Conductor Bar in EMS-Systems

Program 0811

1.3 Replace copper-graphite Collectors with pure graphite Collectors

Fig. 4: Replace copper-graphite Collectors with pure graphite Collectors

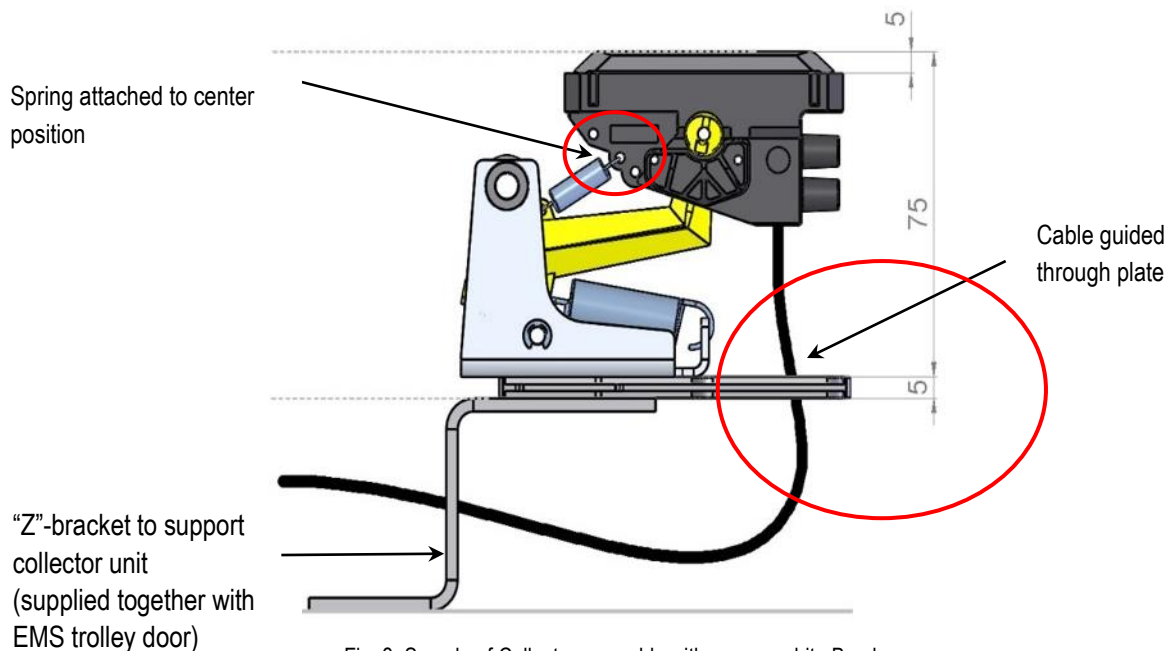
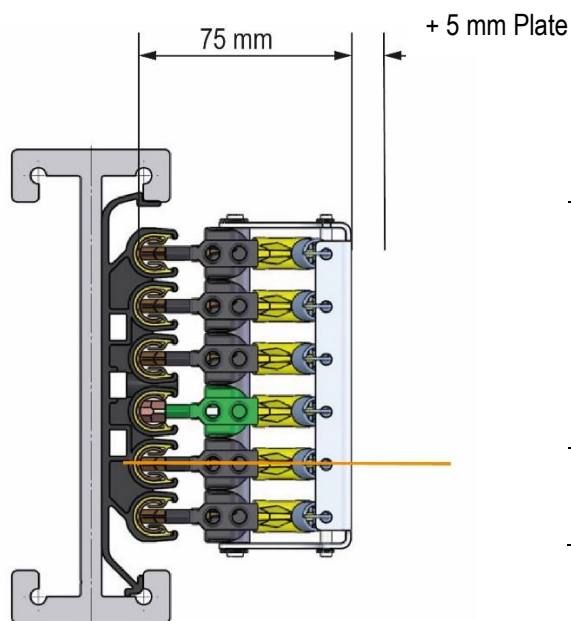
1. Old copper- graphite collector height (when engaged): 80 mm (due to brush head with 10 mm height).
New pure graphite collector height (when engaged): 75 mm (due to brush head with 5 mm height)
Plate 5 mm must be used
2. Collector adjustment: Exact center line of copper rail and brush head to be kept

BMW stipulates a plate with a cable guide 08-P025-0191-001. This plate must be considered for new installations and rebuilding. It allows the obeying of the correct installation dimensions and a safe cable guide.

Fig. 5: Cables which are not installed correctly

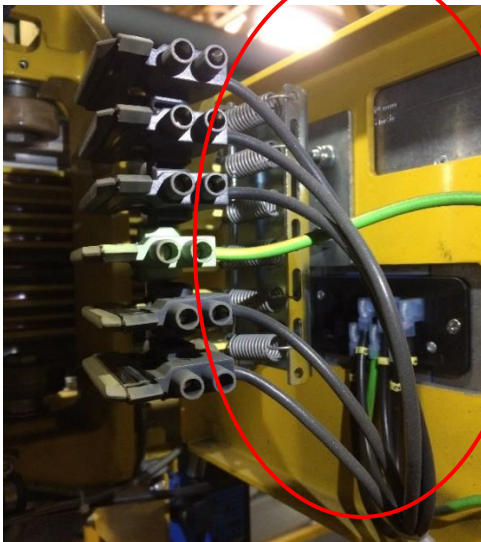
1. Cables are not installed correctly:
 - No parallel cable guide
 - Cable bundle creates force on collector heads
 - Collector heads are not running parallel to conductor rail

Fig. 6: Collector adjustment

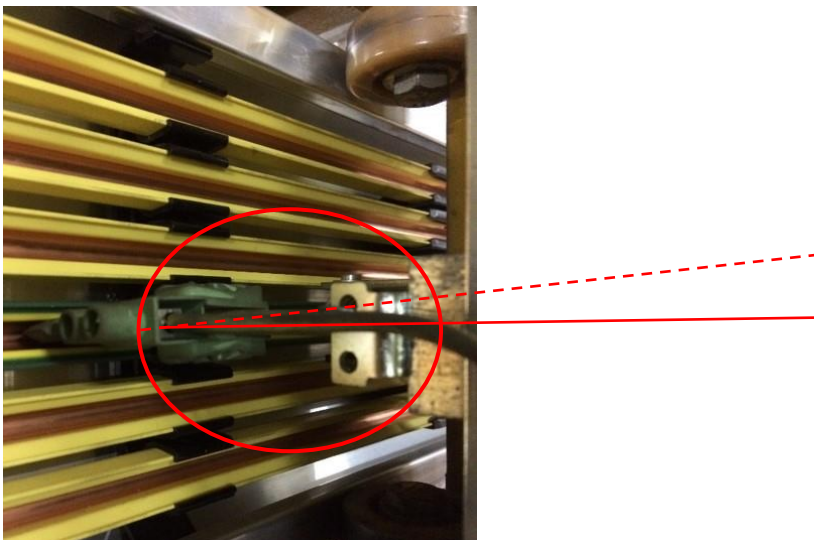
2. Collector adjustment: Brush head not aligned properly (too high!) = Brush head runs permanently in an angle and grinds the plastic isolation of the conductor rail.
